**REQUEST FOR EXCEPTION TO
RAPID CITY DESIGN STANDARD AND CRITERIA**

PROJECT Salvation Army Family Enrichment Center
DATE: 7-13-07 **SUBMITTED BY:** Renner Associates, LLC

EXCEPTION REQUESTED: SECTION 8.2.4 STANDARD/CRITERIA Street Design

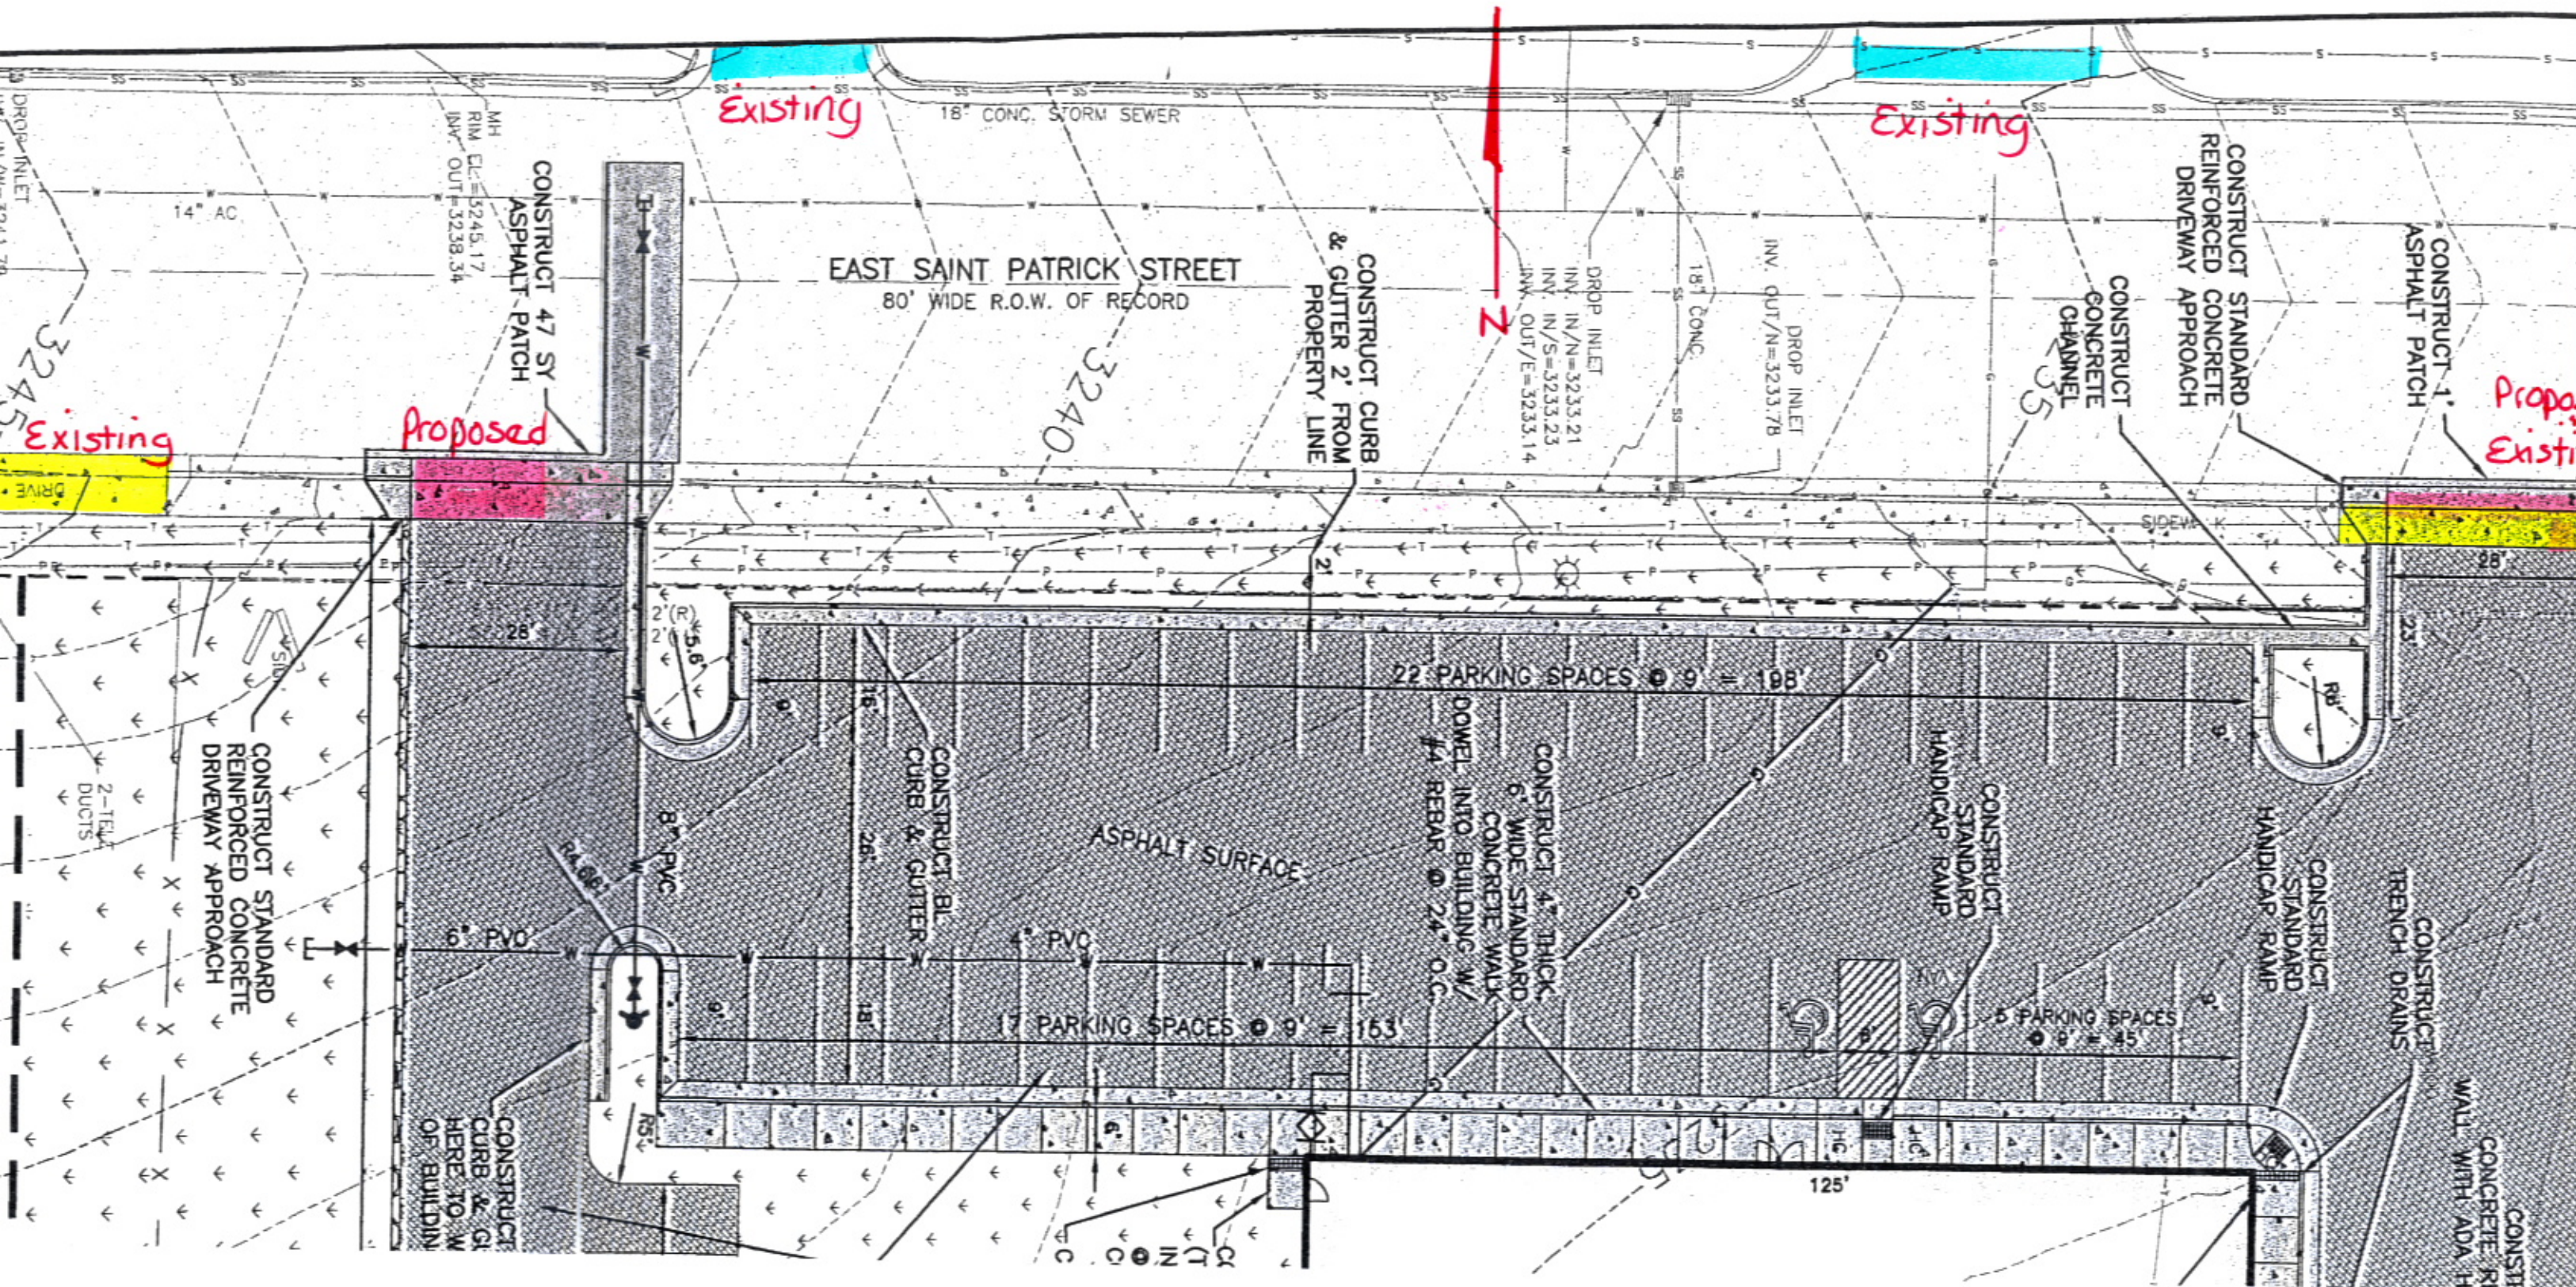
DESCRIPTION OF REQUEST: Request is to allow utilization of the existing approach location for the east approach, located 68' from the nearest opposing driveway, and to allow the adjustment of the existing west approach, to a distance of 35 feet from the nearest opposing driveway.

JUSTIFICATION: 1. The East approach location utilizes the existing location.
2. The West approach is located to accommodate the required number of parking spaces, and to provide for fire and emergency access. The Salvation Army would need to pay for more grading, base course, curb and gutter, asphalt, and water main to comply with current spacing requirements.

There are currently two existing approaches on East Saint Patrick Street to the property applicant is proposing to develop. SDCM allows for two driveway approaches to a business establishment. Applicant is proposing to reconstruct the existing driveway approach at the east end of the property and add a driveway approach between the two existing approaches (a total of three approaches). SDCM also requires the location of driveway approaches to properties on opposite sides of the roadway be located directly opposite each other whenever possible, or a minimum spacing of 75 feet is required. Currently, the existing east approach is located approximately 28 feet from an opposite driveway and the existing west approach is located approximately 68 feet from an opposite driveway. The proposed driveway approach would be located approximately 13 feet from an opposite driveway. See attached sheet. The location of the proposed driveway approach conflicts with existing driveway approaches on the opposite side of the roadway and three driveway approaches to the property has the potential to cause traffic congestion.

Recommendation: Denial **By:** Mary Bosworth **Date:** 7/18/07
